Typical details: where CAD and Revit draw the same detail differently

55 of the 190 CAD typical details have a Revit version in your templates that is drawn differently.

Compared by eye on 2026-10-23 from Nelson's CAD blocks and the Concrete Tower R24 / Steel R24 / Container R23 templates.

CAD: KOR-D301-DET 02 - BASEMENT WALL SECTION

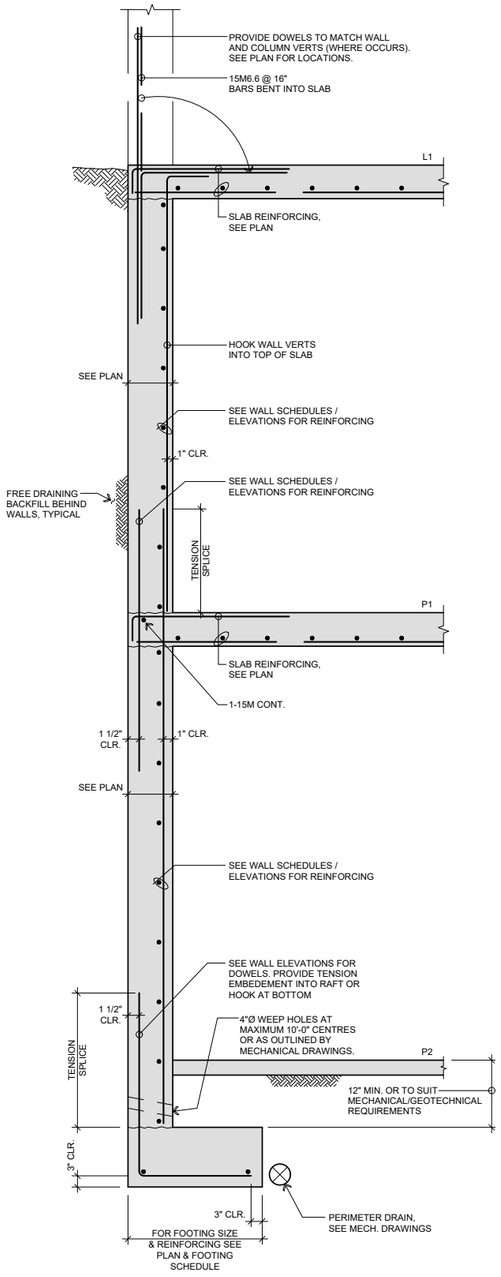
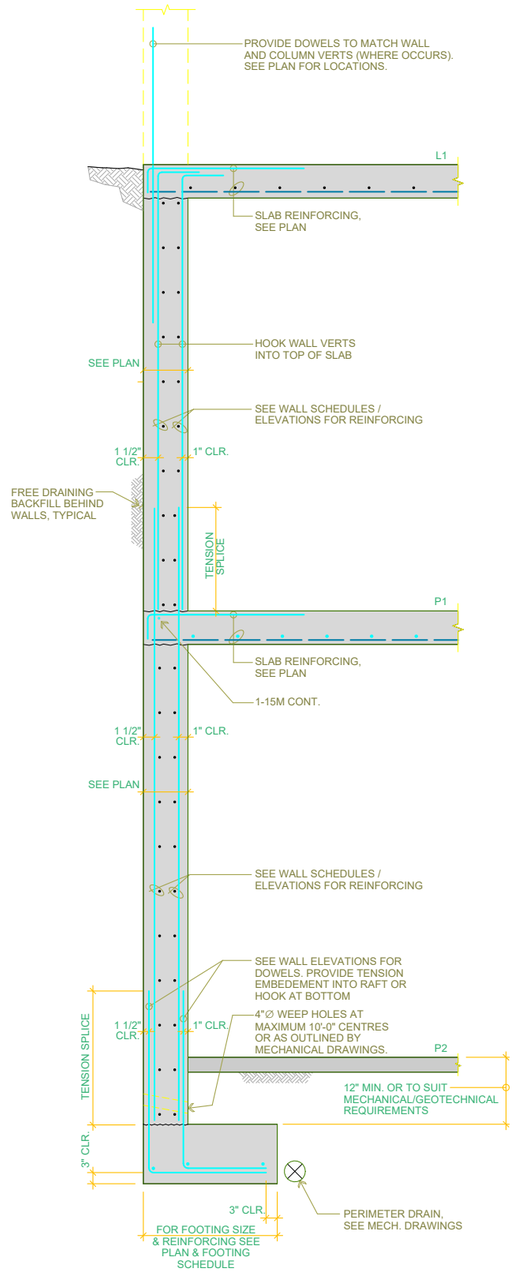
What differs: Same basement wall section but adds a wall-reinforcing-per-schedule callout and 15M bent bars that 'D3.01_1_BASEMENT WALL SECTION' lacks.

CAD: KOR-D301-DET 03 - BASEMENT WALL SECTION

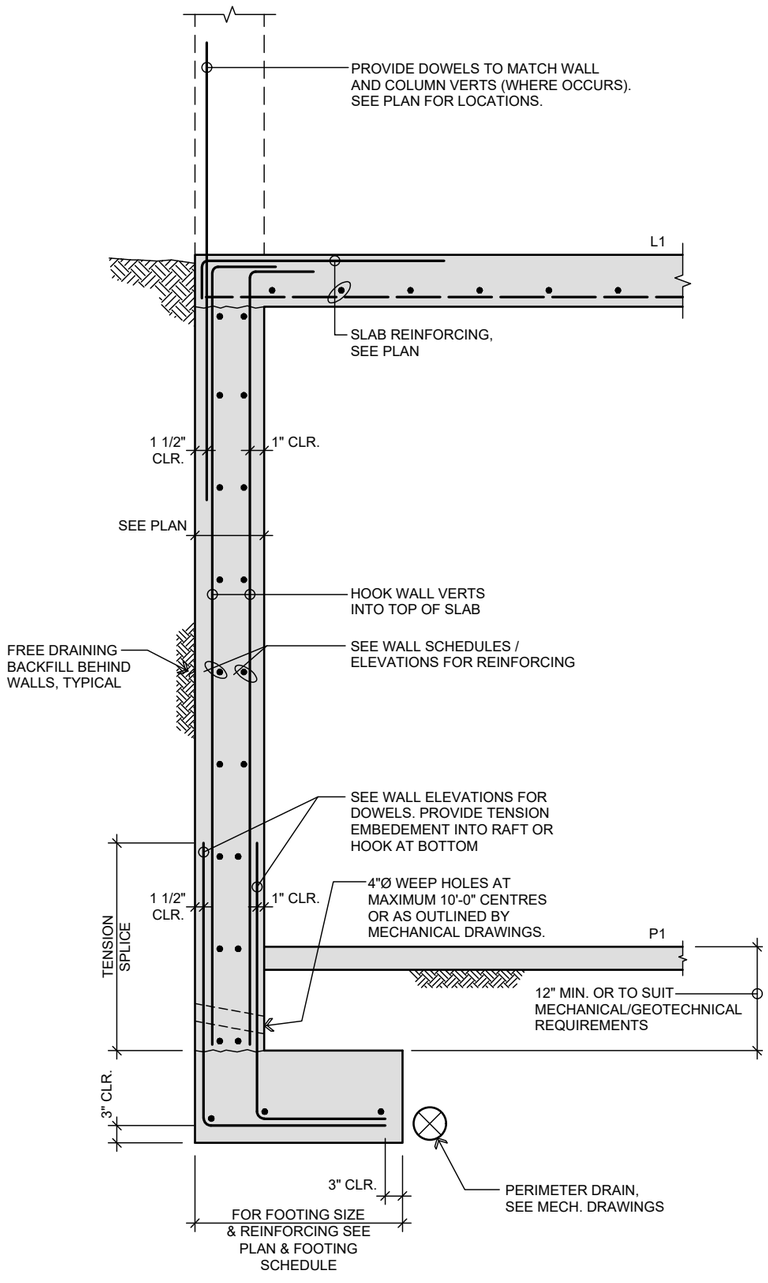
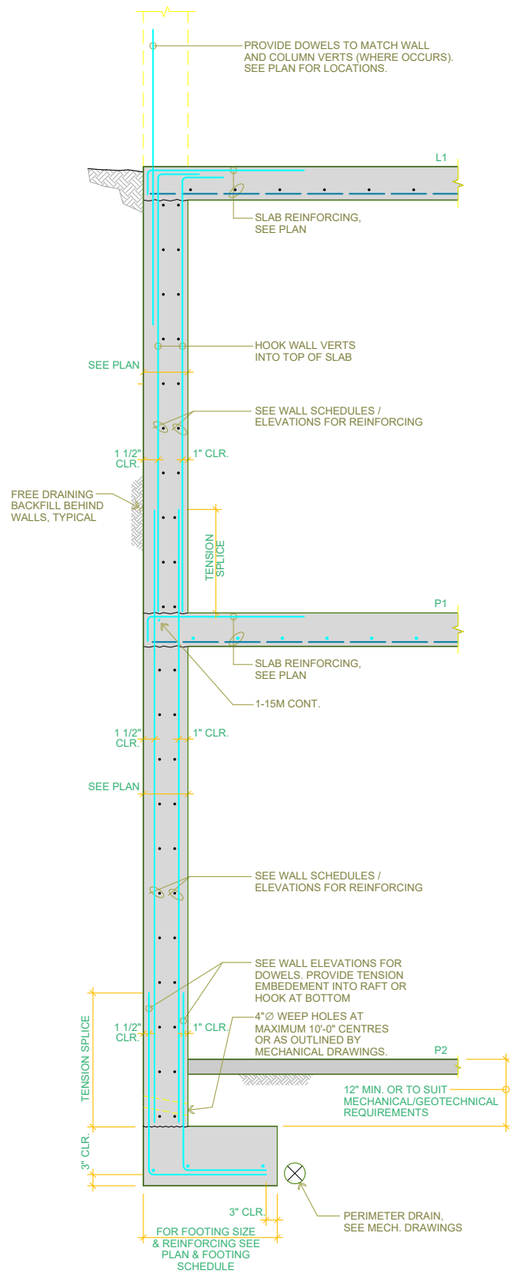
What differs: Single-storey basement wall with one slab and strip footing; 'D3.01_1_BASEMENT WALL SECTION' shows three suspended levels.

CAD: KOR-D301-DET 04 - BASEMENT WALL SECTION

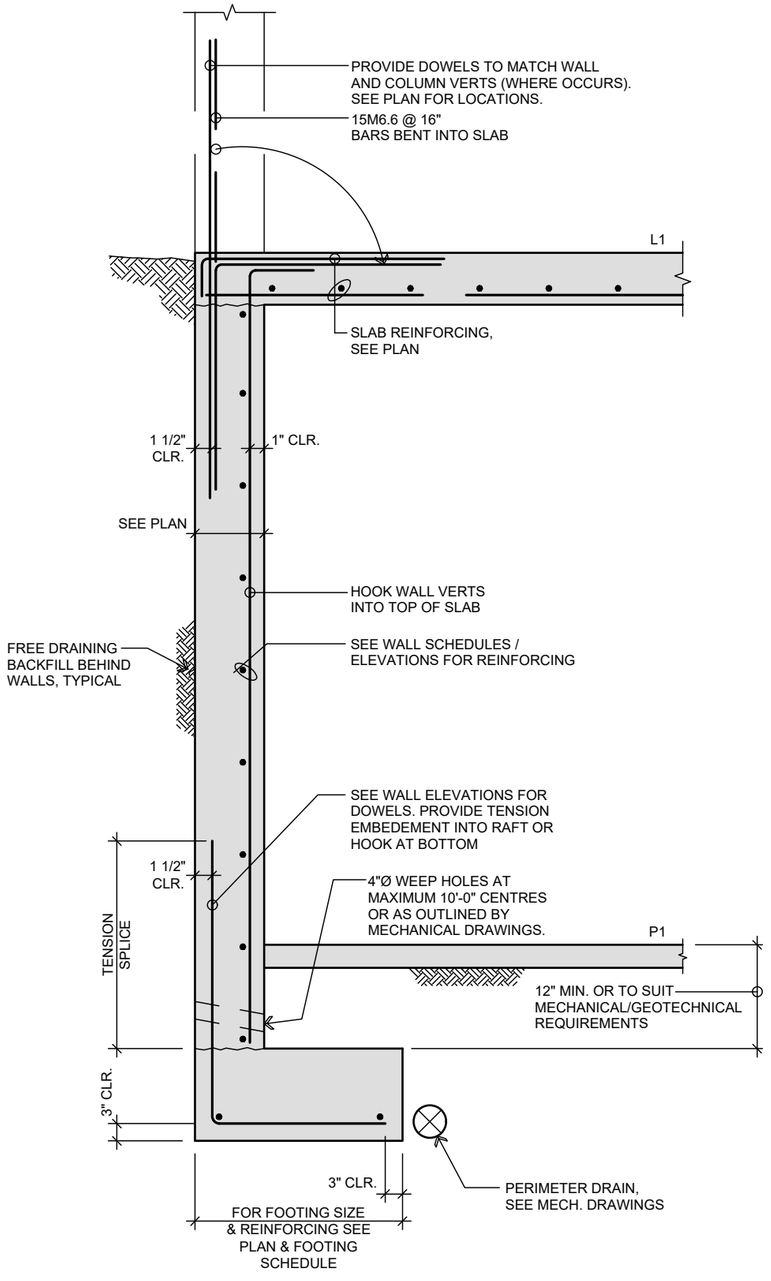
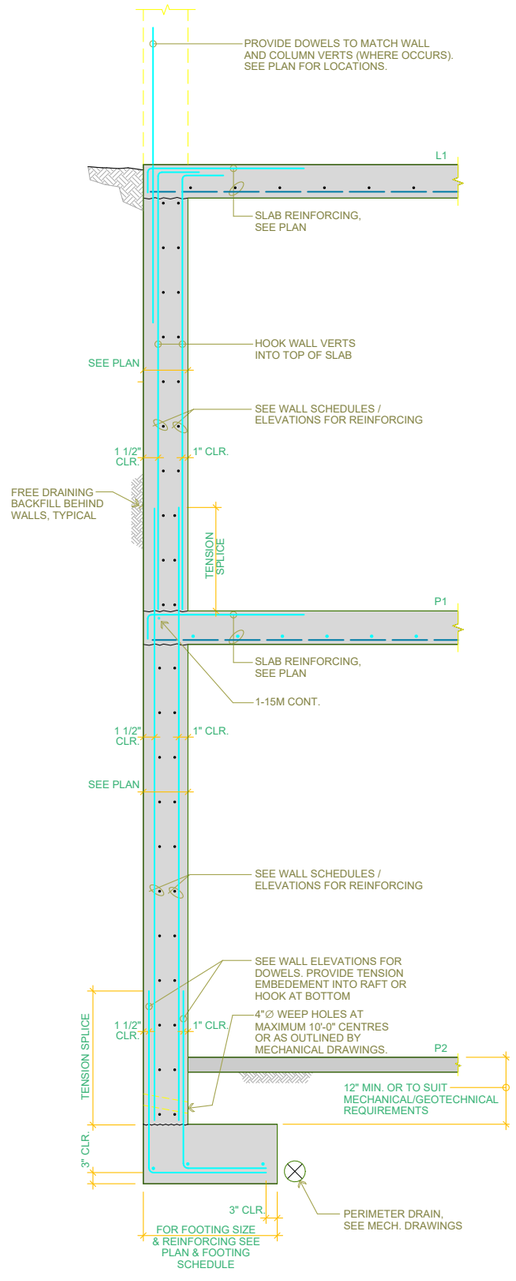
What differs: Single-storey basement wall with slab dowels and footing; 'D3.01_1_BASEMENT WALL SECTION' shows three levels.

CAD: KOR-D301-DET 05 - BASEMENT WALL SECTION

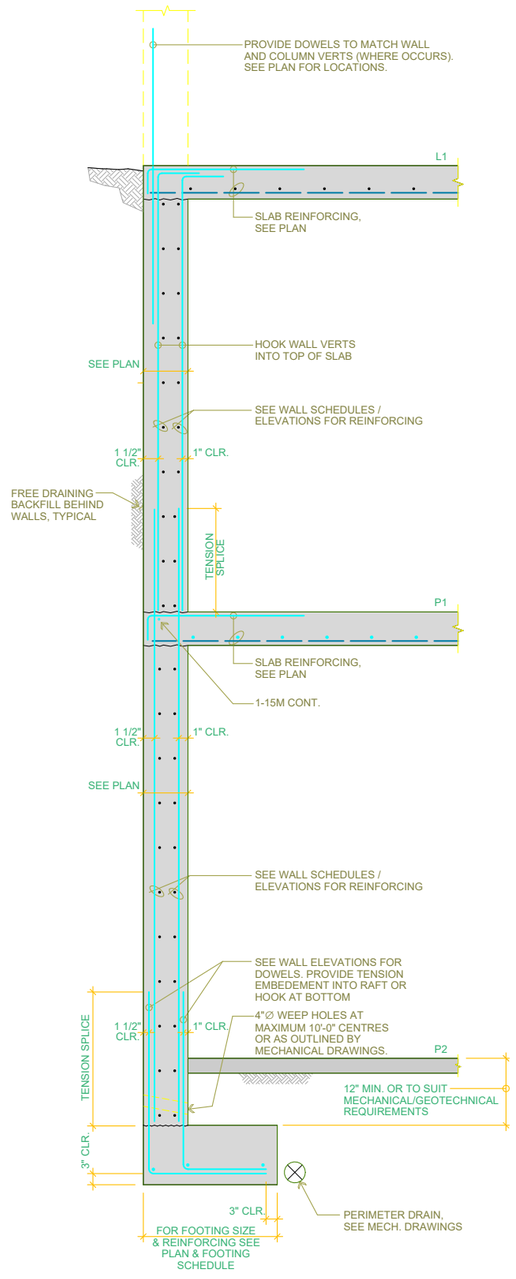
What differs: Tall multi-storey wall with five slabs; 'D3.01_1_BASEMENT WALL SECTION' shows three levels and different callouts.

Revit: D3.01_1_BASEMENT WALL SECTION (Typical Details - Container_R23 (Need_MET & IMP).rvt; on D3.01 Series 3 Basement)

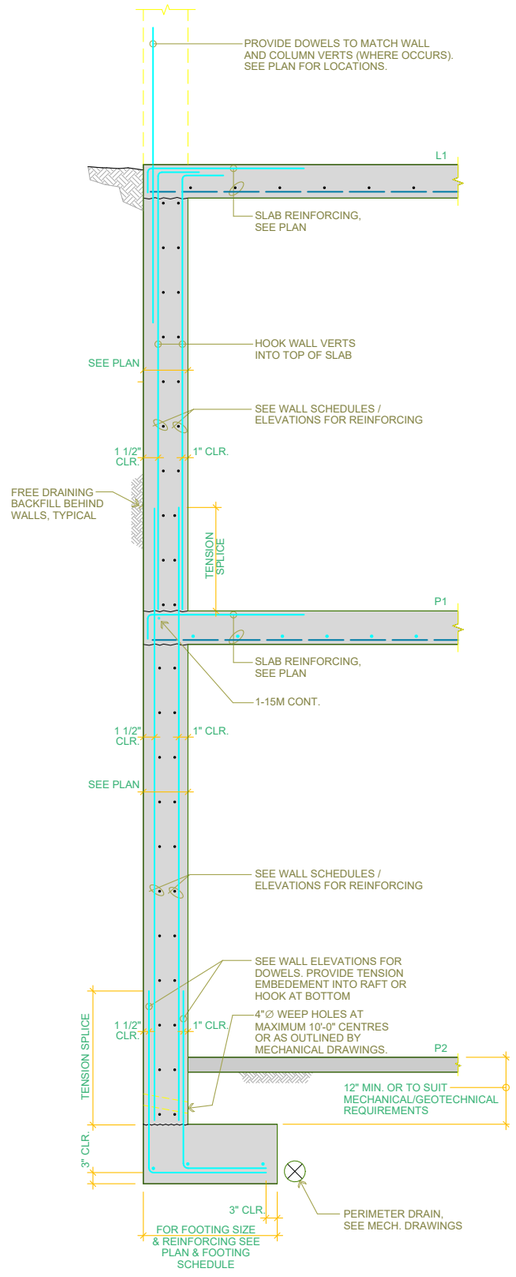
What differs: Tall multi-storey wall with five slabs; 'D3.01_1_BASEMENT WALL SECTION' shows three levels and different callouts.

CAD: KOR-D302-DET 01 - BASEMENT WALL SECTION

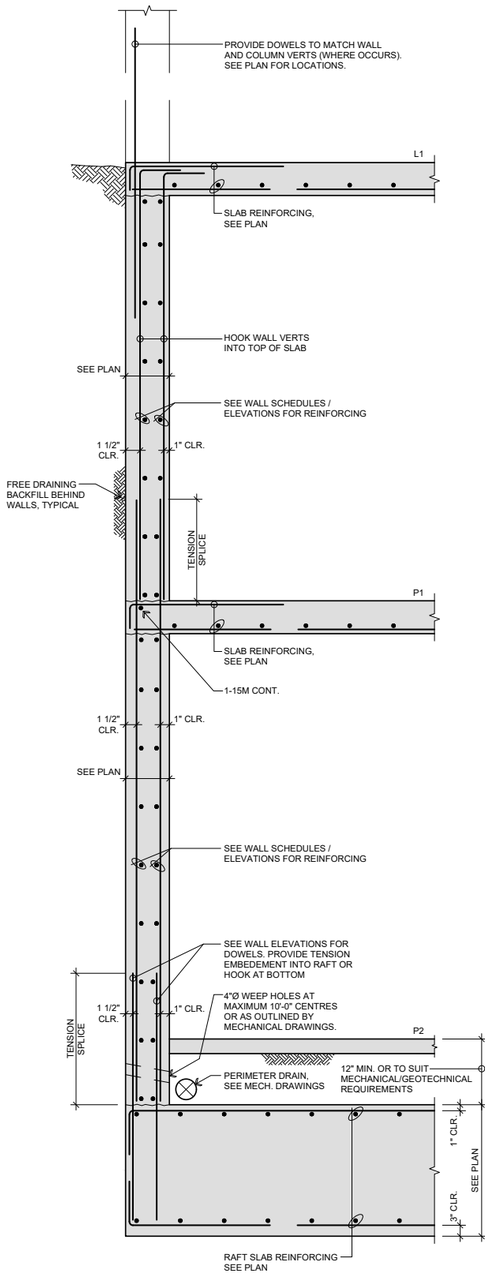
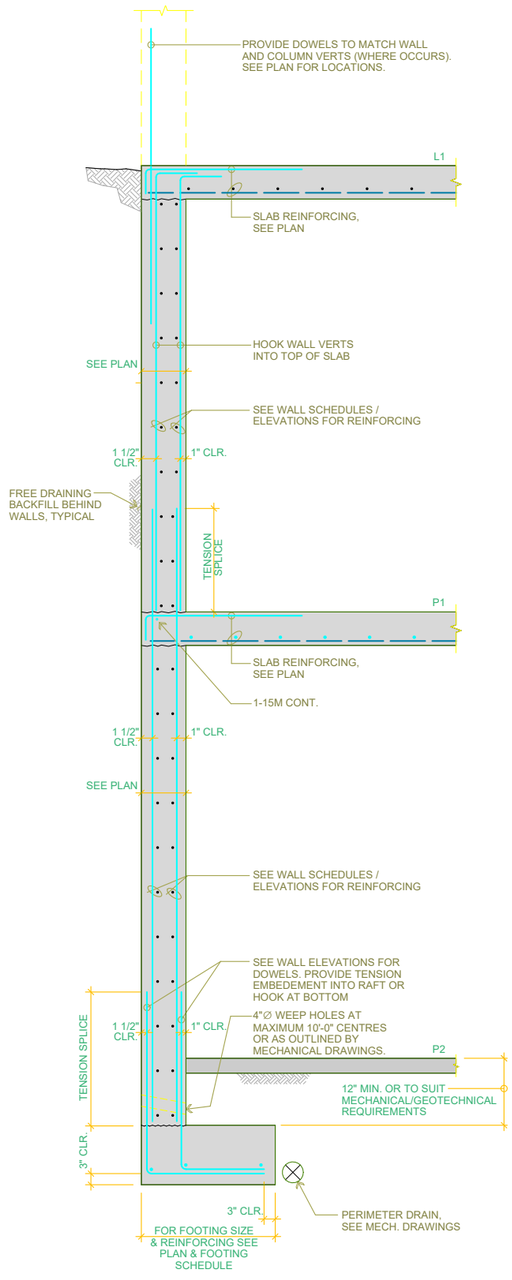
What differs: Basement wall section bearing on a raft instead of a strip footing; otherwise like 'D3.01_1_BASEMENT WALL SECTION'.

CAD: KOR-D302-DET 02 - BASEMENT WALL SECTION

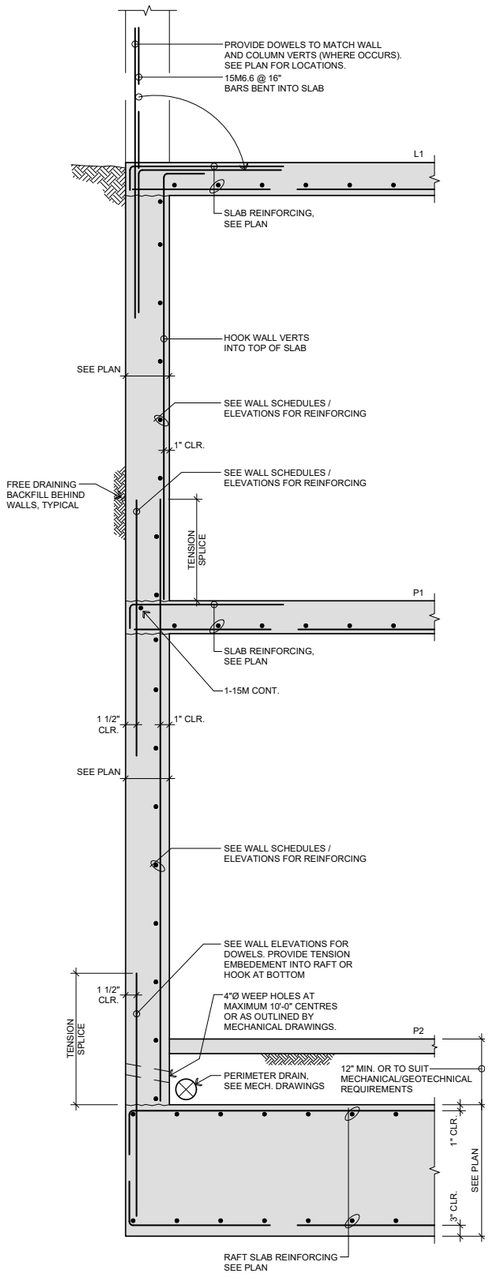
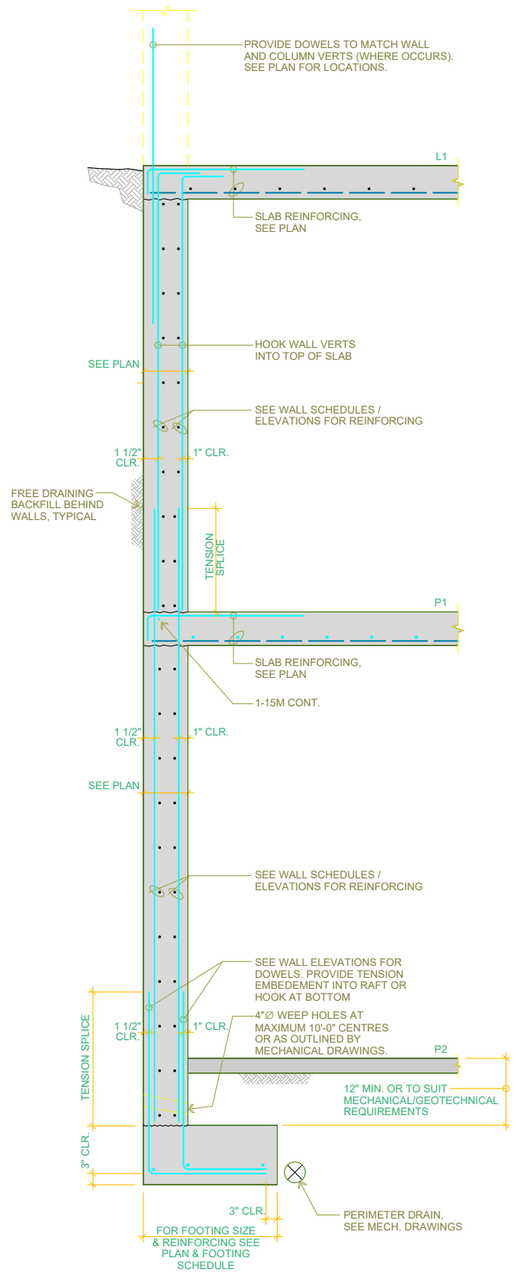
What differs: Basement wall on a raft with extra callouts vs 'D3.01_1_BASEMENT WALL SECTION''s strip footing.

CAD: KOR-D302-DET 03 - BASEMENT WALL SECTION

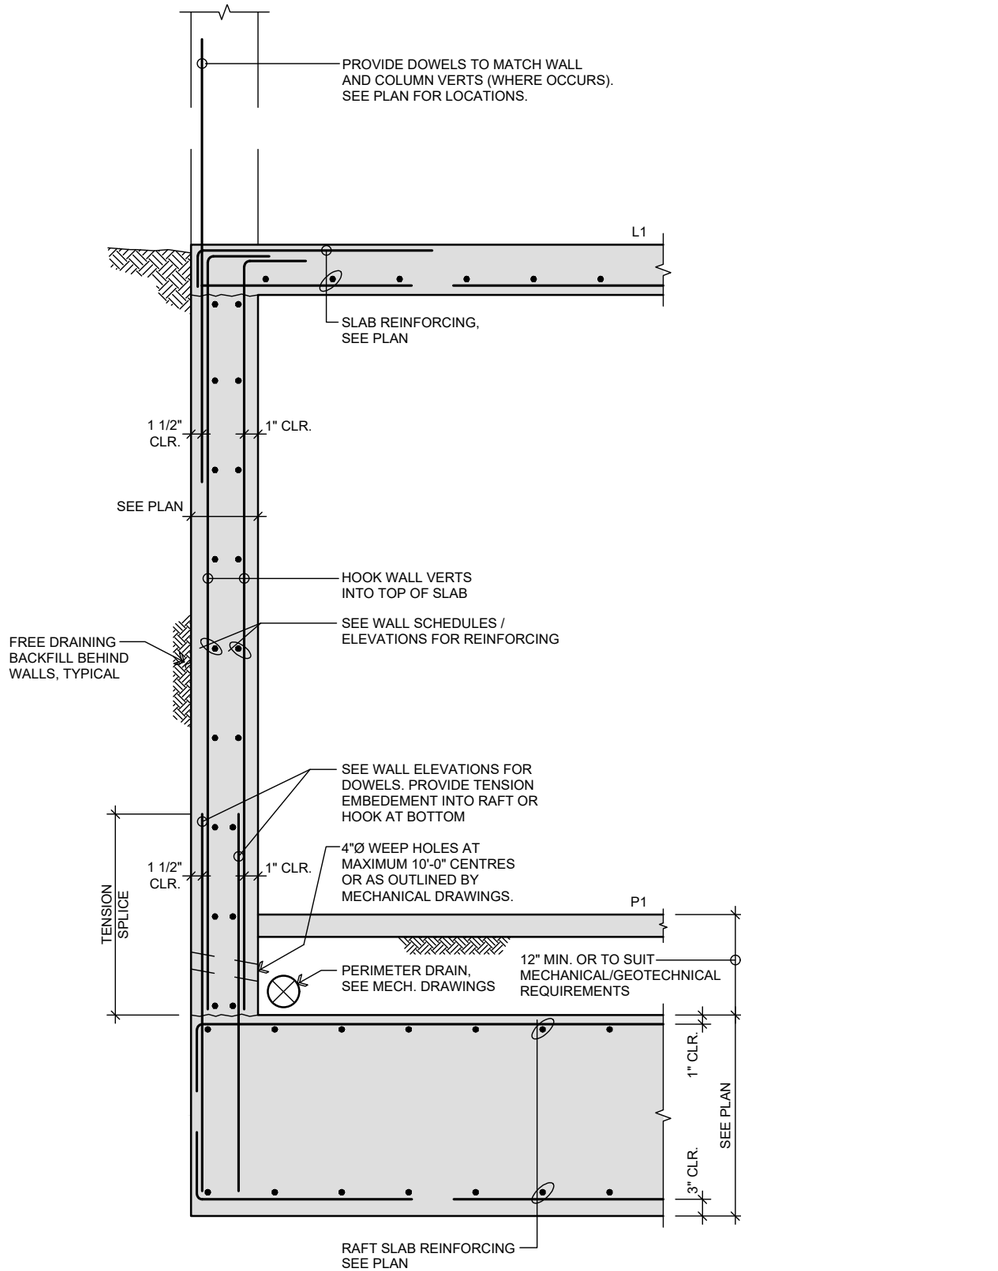
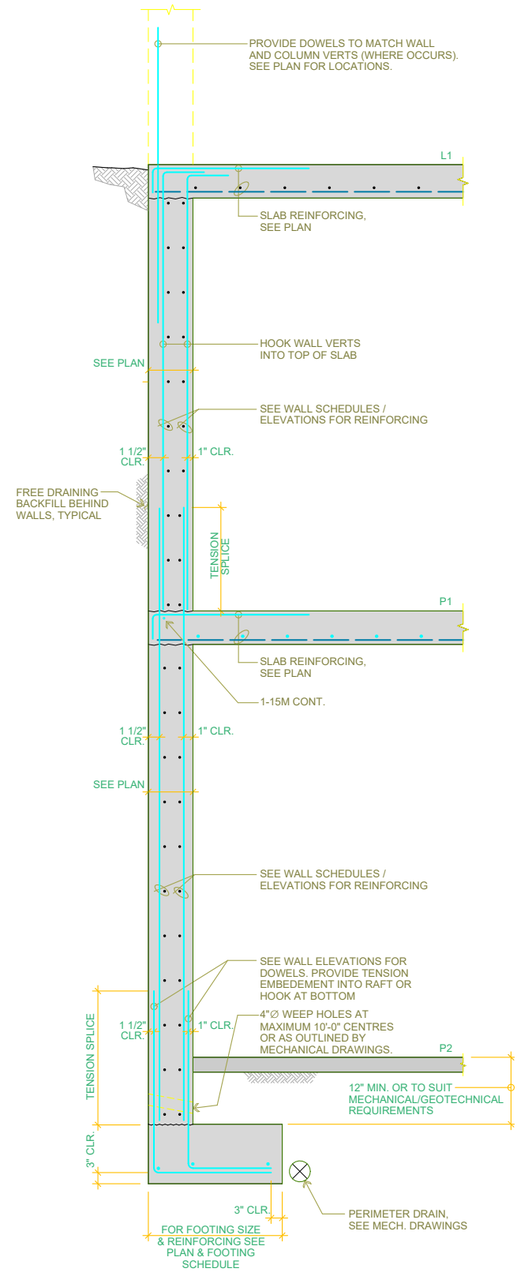
What differs: Single-storey basement wall on raft; 'D3.01_1_BASEMENT WALL SECTION' is three levels on strip footing.
